Value Engineering For Transportation Improvements

I-95 (SR 9) Interchange at Northlake Boulevard

Value Engineering Study Final Report

Project Description: I-95 (SR 9) Interchange at Northlake Boulevard

RECOMMENDATION No. 33: Do not build the additional dedicated right turn lane northbound Sandtree Drive to eastbound Northlake Blvd. convert the through lane to a shared through and right turn lane

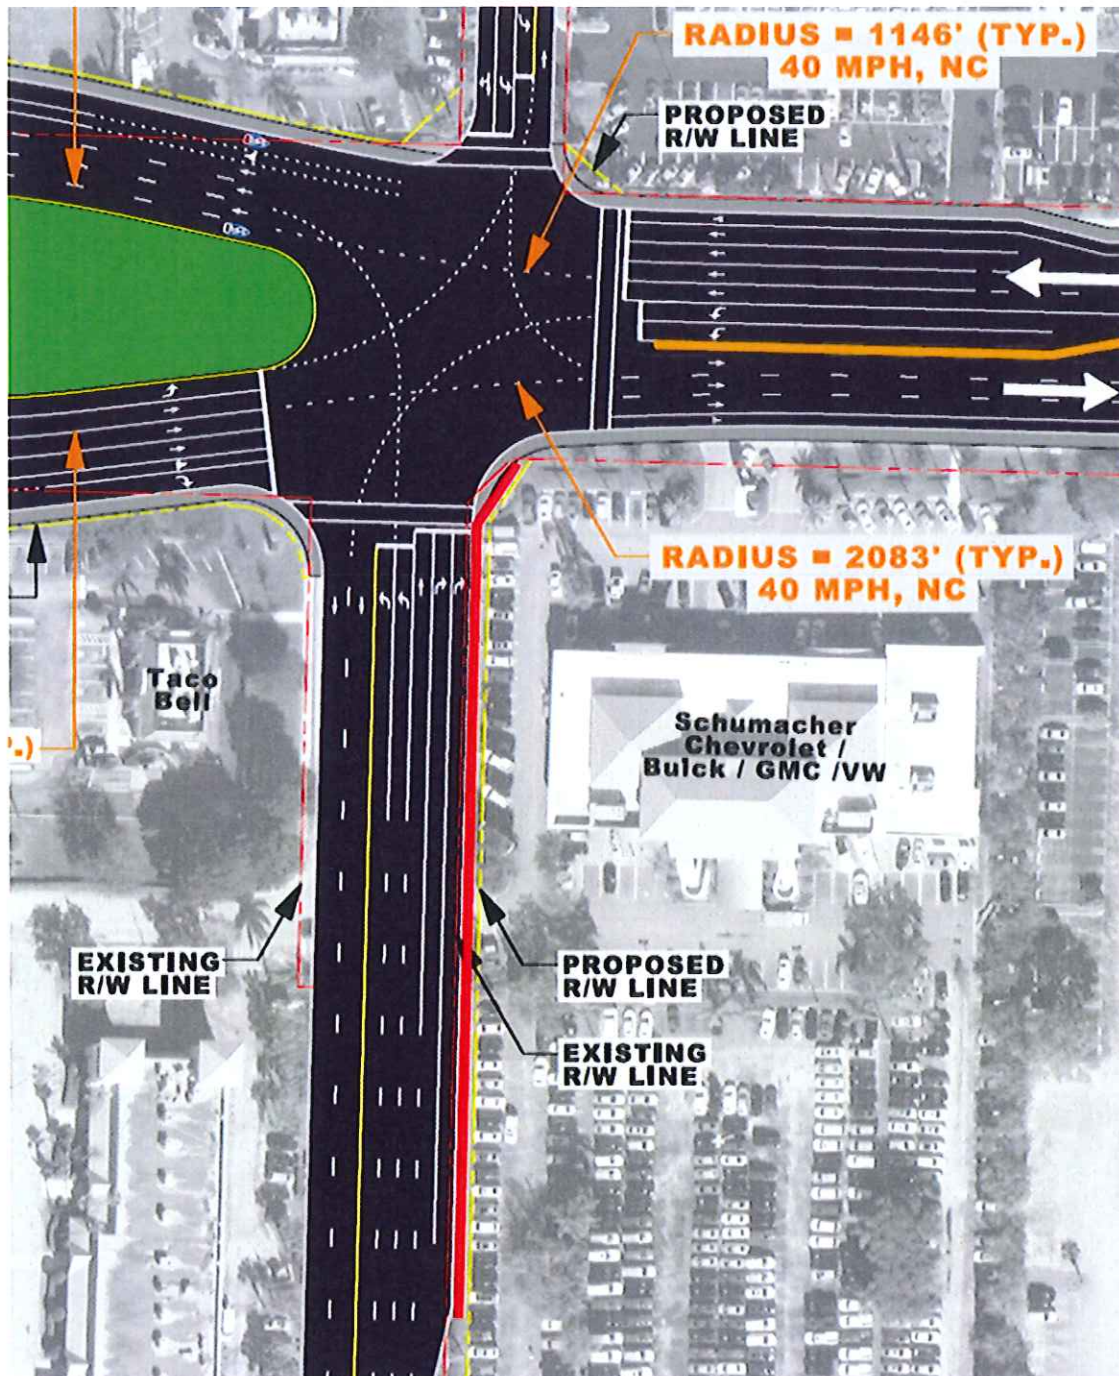
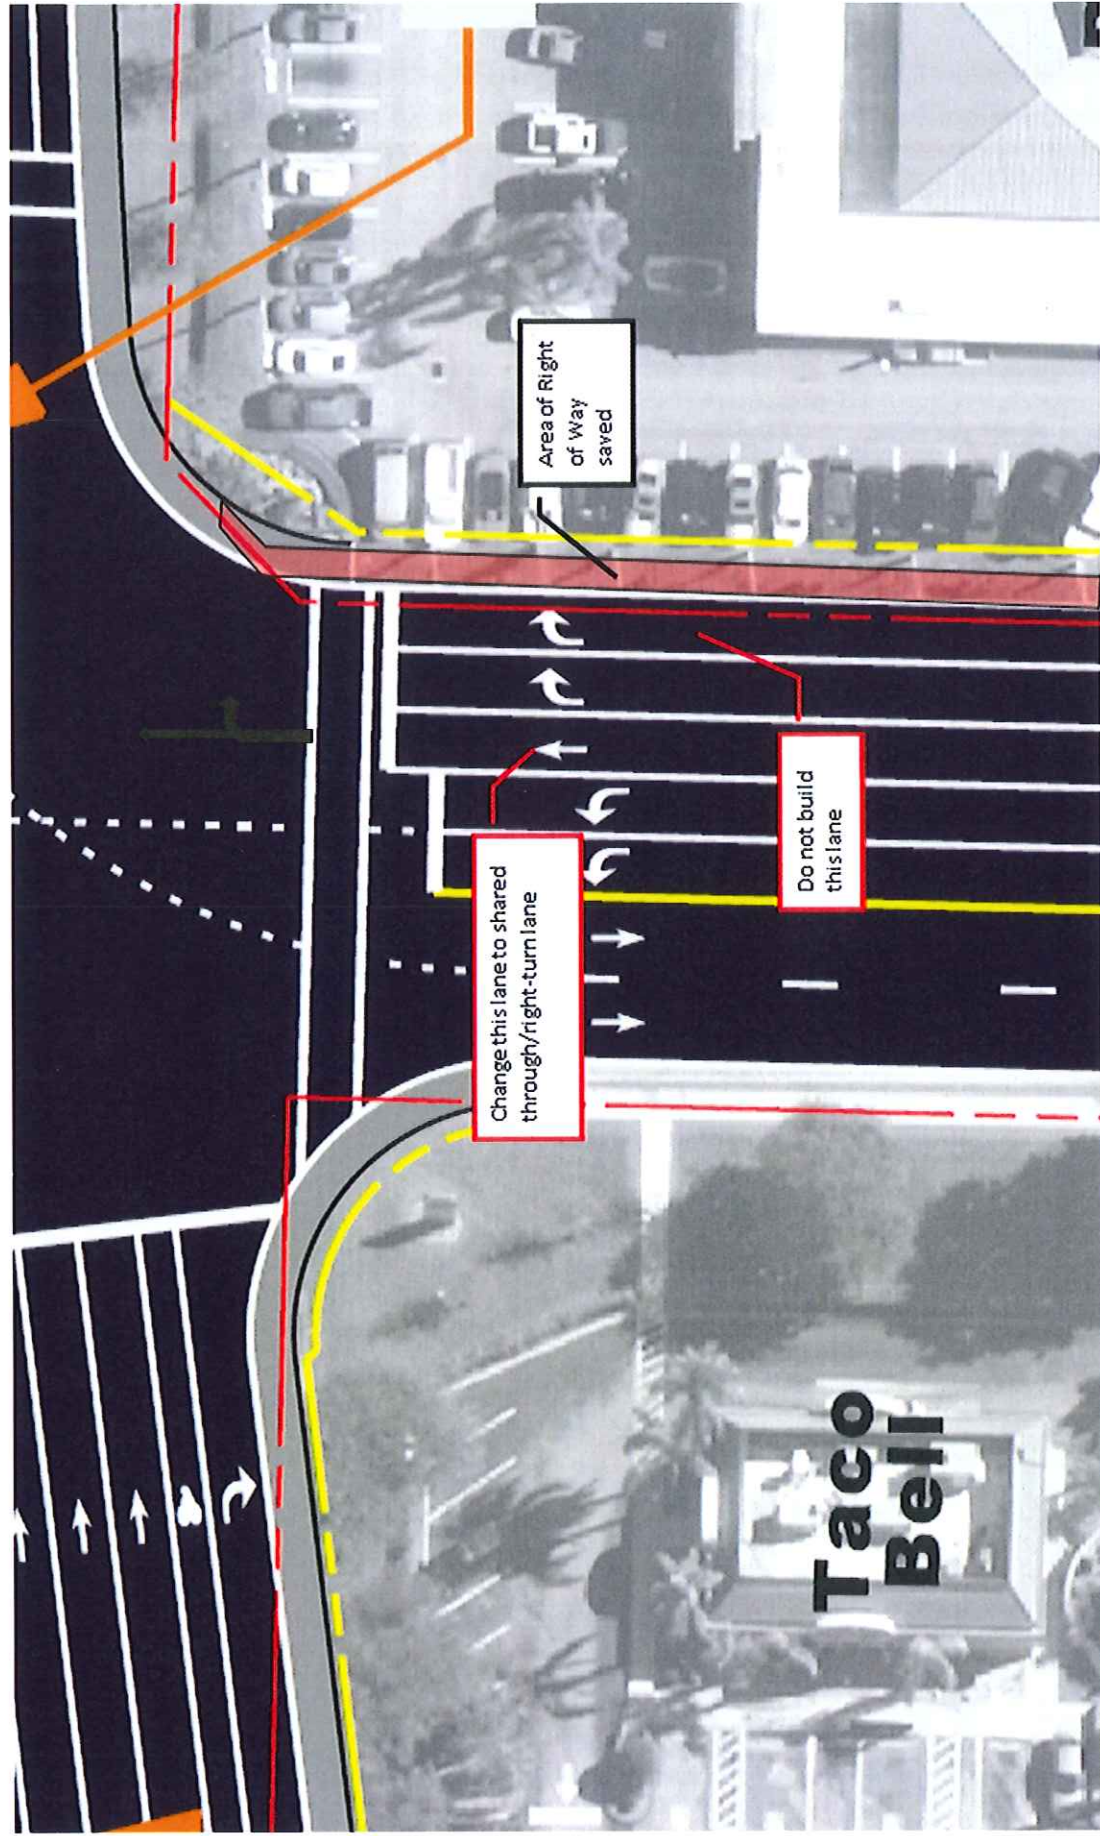
VE Recommended Change: Do not build the additional dedicated northbound to eastbound right turn lane at Sandtree Drive. Convert the through lane to a shared through/right turn lane. The through movement only has 20 vehicles during the peak hour flow. Potential construction cost savings is \$6,400,000 when compared to Alternative 2, DDI cost.

PD&E Design Response: Accepted

CREATE FREE FLOW OFF-RAMP
RIGHT TURNS FOR ALTERNATIVE 1

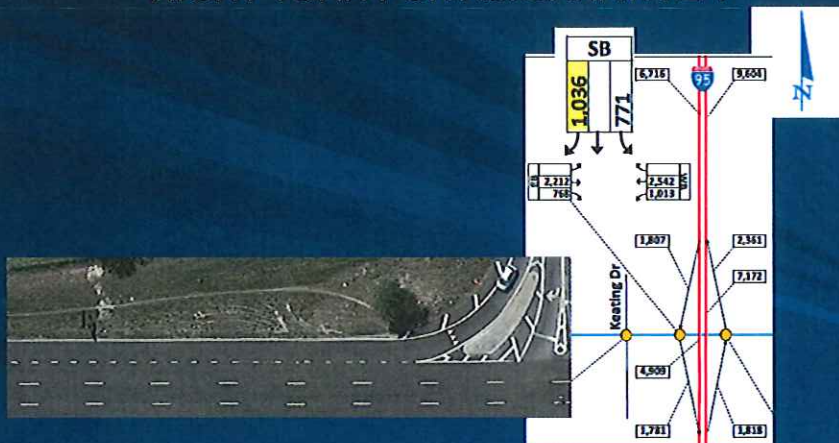
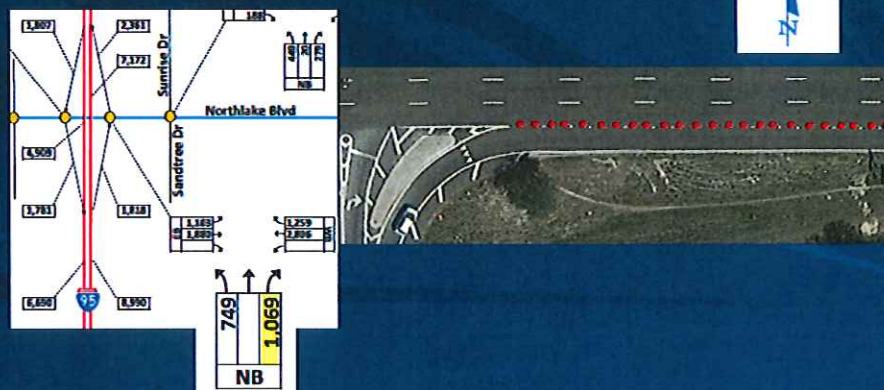
- **VE Idea No. 3:** Construct Alternative 1 as described in the PD&E documents at I-95 and North Lake Blvd, and construct free flow off-ramps for the right turns.

Reduce the 7-ft bike lane and buffer

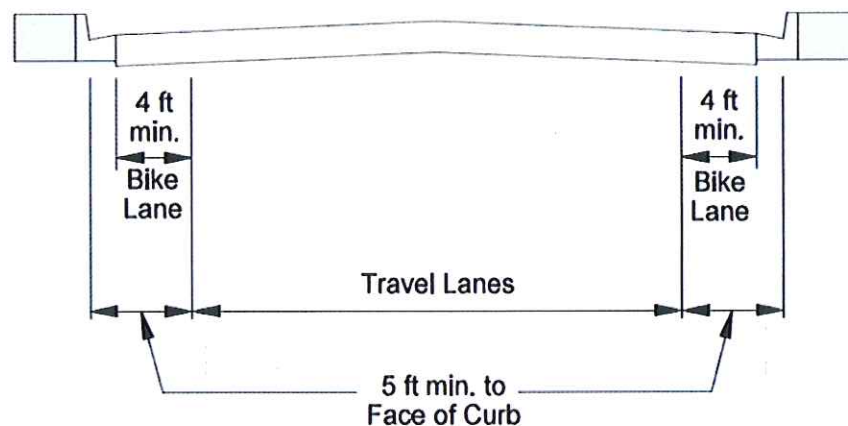
- **VE Idea No. 16:** For all alternatives, reduce the 7-foot bike lane and buffer to 4 feet, per Palm Beach County standards, saving 3 feet on each side for a total reduction of 6 feet of roadway.

VE Recommended Change: For all alternative options, reduce the 7-foot bike lane and buffer to 4 feet, saving 3 feet on each side. Potential cost savings \$726,000 for all alternatives.

PD&E Design Response: Accepted
